## C S Stokes and Associates Limited

**Subject:** HIU's within the hallways of some Grenfell Tower flats which are located on the existing electrical supply/distribution board cupboard.

Photograph A

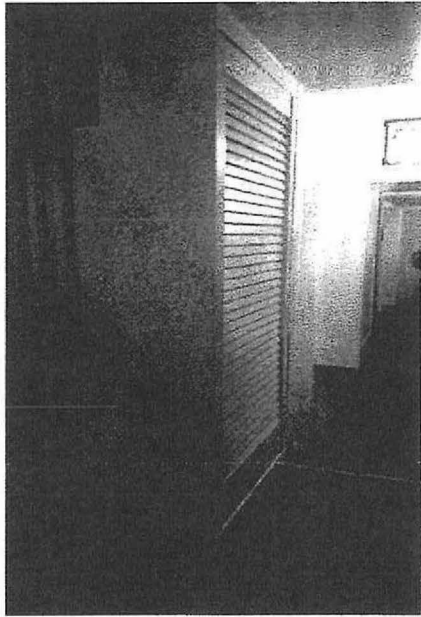
Please see a photograph on the left below, (A) this was taken on Tuesday the 15<sup>th</sup> December 2015 within one of the flats where the HIU is positioned on the wall just inside of the flat entrance door above the existing electrical cupboard. The local Authority Building Control Officer has agreed the location of this unit in the hallway of the flats concerned and this location complies with the requirements of the Building Regulations. This includes the Fire Safety aspects of the Regulations, so by complying with the requirements of the Fire Safety, Approved Document B of the Building Regulations the positioning also will comply with the requirements of the Regulatory Reform (Fire Safety) Order 2005.

Photograph B

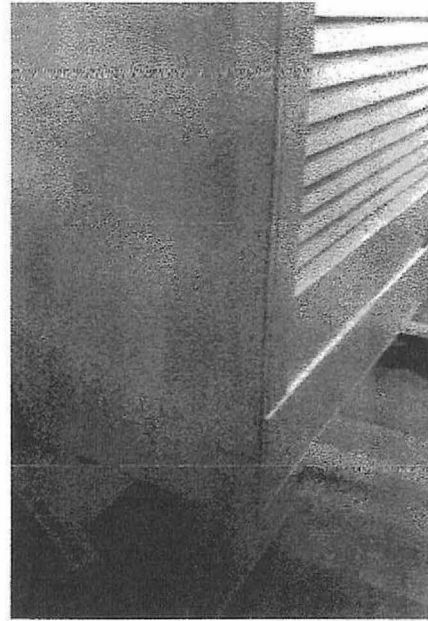
The photograph on the right (B) below shows the overhang of the timber constructed cupboard with a louvered door containing the HIU in comparison to the existing electrical supply/distribution board cupboard. The width of the hallway is 1170mm, the existing electrical supply/distribution board cupboard comes out from the wall 180mm and the HIU cupboard comes out from the wall 330mm. There is a 150mm overhang by the HIU cupboard into the hallway more that the electrical cupboard.

This leaves a clear width/gap of 840mm from the front face of the HIU cupboard to the other wall of the hallway. All of the above measurements were taken from one flat but the width of the hallways is the same within each dwelling and from what I have been told the HIUs have been positioned in similar locations. Photograph C below shows the HIU within the timber constructed cupboard with a louvered door open.
